ZETA-THREE

TECHNICAL BULLETIN #1

Time Code Reader Input Improvement

November 15, 1988

FIG 1

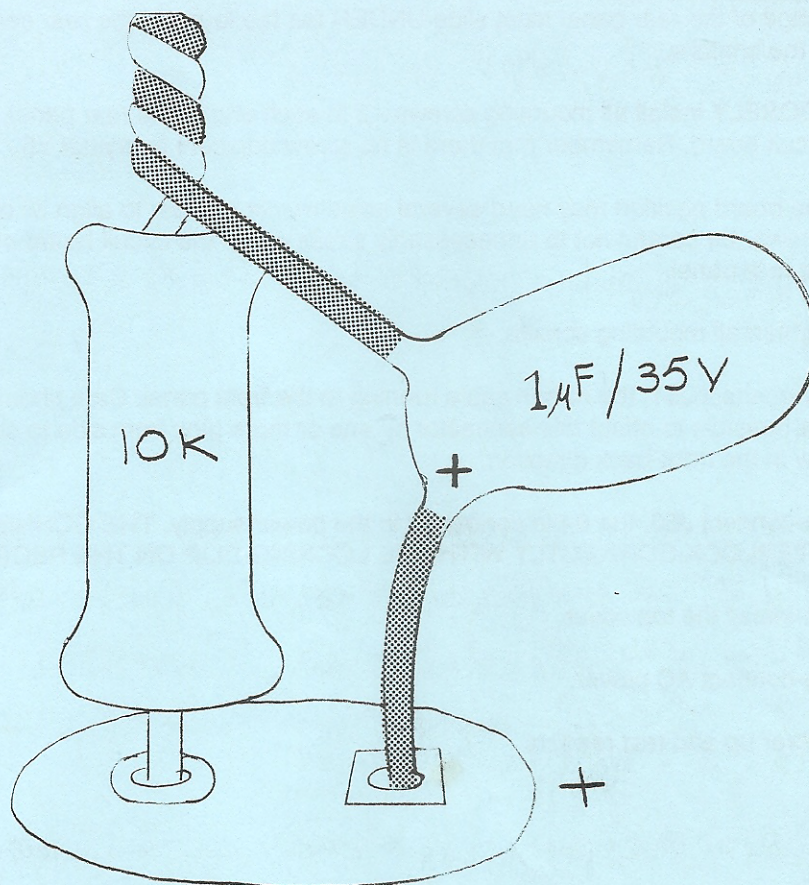
Under some circumstances, the Time Code Reader inputs of some Zeta Three's in the field have shown a tendency to fail when exposed to sharp transients.

The usual symptom of the problem is that one of the Zeta readers stops reading time code completely. A secondary symptom is that the reader may continue to function, but only if excessively high Time Code levels are sent to it.

The usual fix for the problem has been the replacement of one or both of the CA3080 integrated circuits U19 (Master reader) and U8 (Slave reader).

To replace capacitors C54 (Master reader) and C24 (Slave reader) each with an identical resistor/capacitor network.

10. Prepare two resistor/capacitor networks. Each is constructed by twisting together one lead of a 10K resistor and the NEGATIVE lead of a 1μF/35volt capacitor. The twisted leads should be soldered and the excess clipped off. (See Fig 1)
11. Install and solder one each of these networks in capacitor positions C54 and C24 as shown in Fig 1.

NOTE: THE "+" SIGNS PRINTED ON THE ZETA CIRCUIT BOARD ARE VERY MISLEADING, AND SHOULD BE IGNORED.
THE POSITIVE LEAD OF THE CAPACITOR MUST BE SOLDERED INTO THE SQUARE PAD, WHILE THE RESISTOR IS SOLDERED INTO THE ROUND PAD.
SEE FIG 1.
